Swedish Radiation Safety Authority

Technical Note

2012:41

Hydrogeological conditions at
the Forsmark site

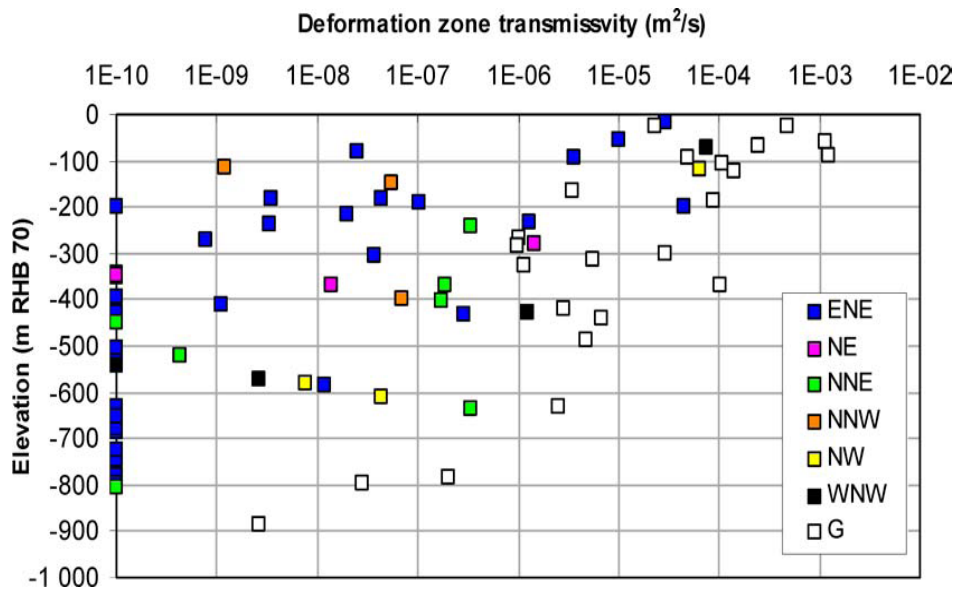
When the data for each set of deformation zones are considered separately, the idea of a single trend with depth becomes questionable. For gently dipping zones (set G in Figure 1.1) and the steeply dipping ENE and WNW sets, a decreasing trend with depth is apparent. However, for the NNW set, the highest transmissivity is seen at the deepest measurement point. For the NE set, data are available only over a depth interval of about 100 m; the deepest measurement is intermediate to the two shallower measurements. For the NNE set, three measurements points between -450 m and -800 m were below 10^{-9} m²/s, but the other four measurements, from about -240 m down to -630 m, are remarkably uniform in the range $2-4 \times 10^{-7}$ m²/s. For the NW set there are just three measurements: a single high value at about -100 m, and two lower values near -600 m.

If data from above -150 m (i.e., within the range where tests are likely to be affected by highly transmissive, sub-horizontal sheet joints) are excluded, the gently dipping set is the only set that shows clear evidence of a trend with depth. The ENE set shows an increase in the proportion of tight sections below -600 m. However in the range -100 m to -600 m its dominant characteristic is a very wide scatter of transmissivity values, suggesting a high degree of heterogeneity.

Thus the transmissivity data from deformation zones could just as well support an alternative interpretation in which only the gently dipping zones show a regular pattern of transmissivity decreasing with depth, while the steep zones are essentially random (dominated by heterogeneity which ranges over 5 orders of magnitude) in the interval -100 m to -600 m, then predominantly tight below -600 m. However, such an interpretation, or any other alternative to the assumption of a single trend with depth for all zones, has not been tested for SR-Site.

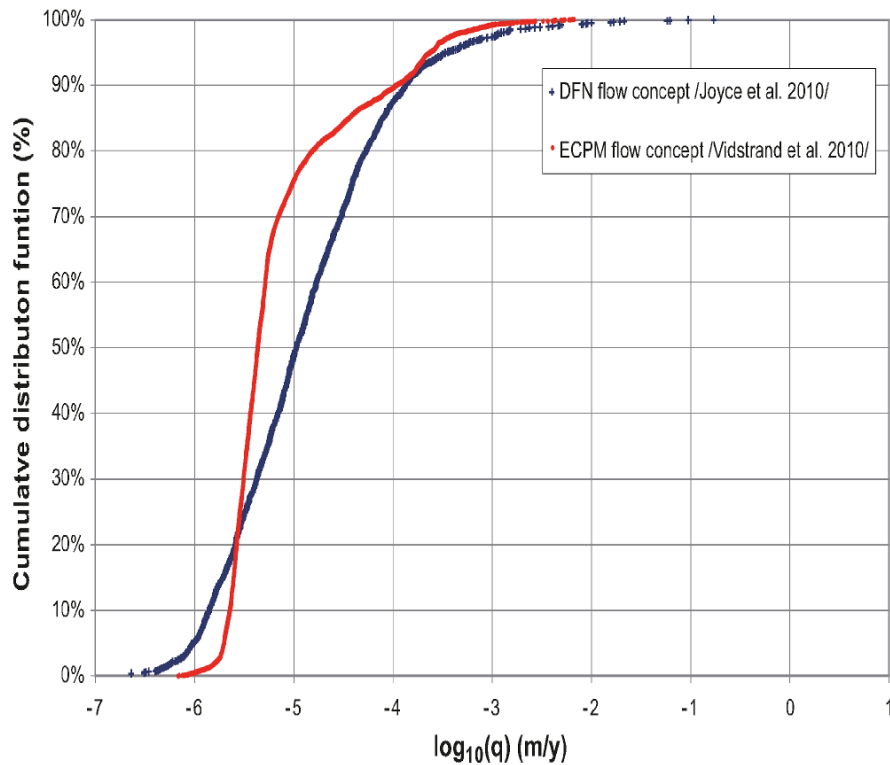
In simulations using DarcyTools (R-09-21), an ECPM representation is used for the rock containing the repository. The consequences of this representation for calculating flows to the repository are discussed in R-09-22 (p. 113). As seen in Figure 1.2, differences are seen in the distribution, primarily in terms of lower variance and a reduced fraction of deposition holes with Darcy flux higher than 10^{-5} m/yr. As noted in R-09-22, the tails representing the high values of Darcy flux are similar despite the differences for lower values. However, the most extreme flows, to the top one percentile of deposition holes (as represented by the blue symbols close to the top edge of the plot) are underpredicted by a factor of 10 to 100, by the ECPM representation.

Figure 1.5: Comparison of alternative relationships between fracture transmissivity and fracture transport aperture.

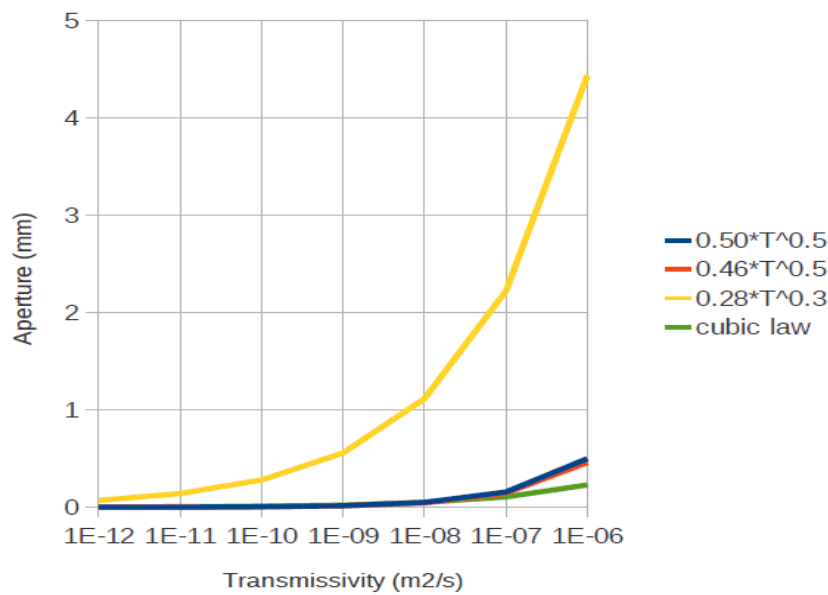
These relationships are plotted in Figure 1.5 together with the “cubic law” which is the expected relationship between aperture and transmissivity for laminar flow of water through an idealized parallel-plate fracture which has a perfectly uniform aperture. It is apparent that the Hjerne et al. (2010) model gives the highest apertures, particularly for the higher transmissivity fractures, while the cubic law gives the lowest apertures. The rounding of the base-case model's coefficient from 0.46 to 0.5 is seen to have very little effect.

Considering that both the base-case model and the Hjerne et al. (2010) model are empirical models fitted to different sets of experimental data, it is doubtful that these bound the range of reasonable possibilities. The cubic law gives consistently smaller apertures than either of these empirical models, and thus yields shorter water residence times for a given transmissive network. On the other hand, the cubic law also gives a higher ratio of wetted surface per unit volume water in the fractures, which offsets the effect of shorter travel times in terms of F factor (transport resistance) calculations.

Figure 2.1: Pressure interference (Pa) at -150 m elevation for a simultaneous operation of an extended SFR and a deep repository in the target volume for the deep high-level waste repository at Forsmark. From R-09-22 Figure 4-7.

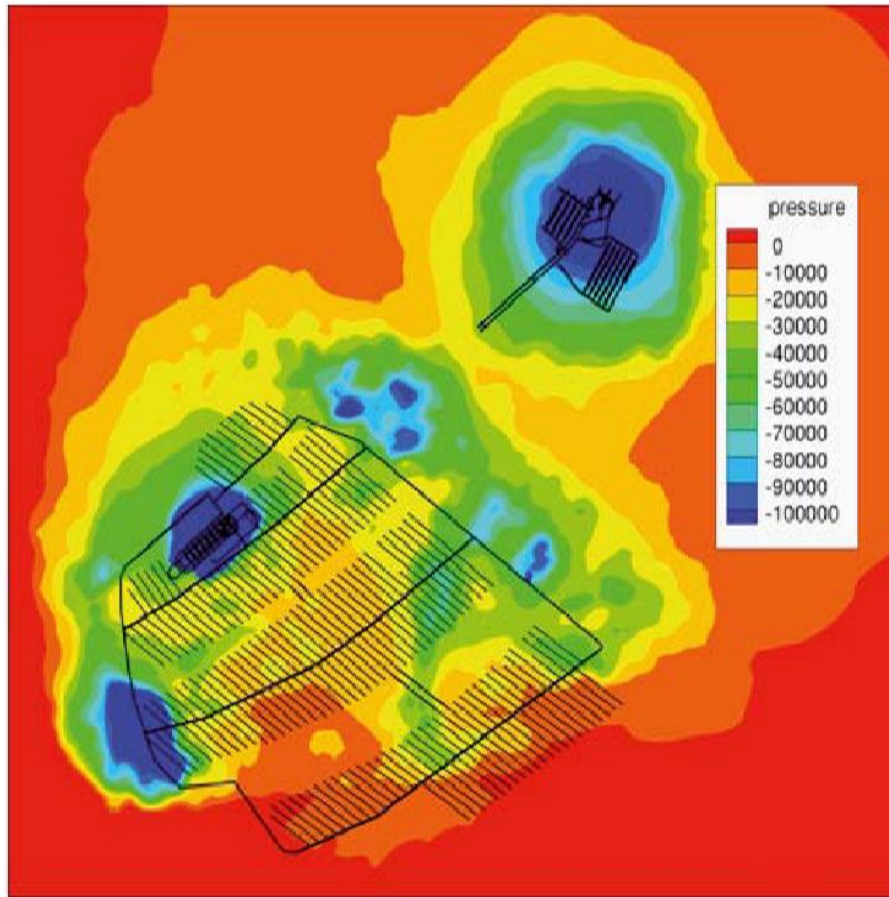
What is the effect of no-flow boundary conditions on the calculated inflows to the deep repository and an extended SFR, during a period of simultaneous operation? From Figure 2.1 it can be seen that, in the model of this situation, drawdowns up to 10% of the maximum drawdown extend to the north and east boundaries of the model domain. How significant are the reductions in inflows due to this artificial restriction at the model boundary?

8. What is the effect of no-flow boundary conditions on inflows to repository & SFR? (See Figure 2.1).
9. Should the extended spatial variability case be propagated throughout the safety assessment, as it appears to be more realistic and produces shorter discharge paths and lower F values in the late temperate period.
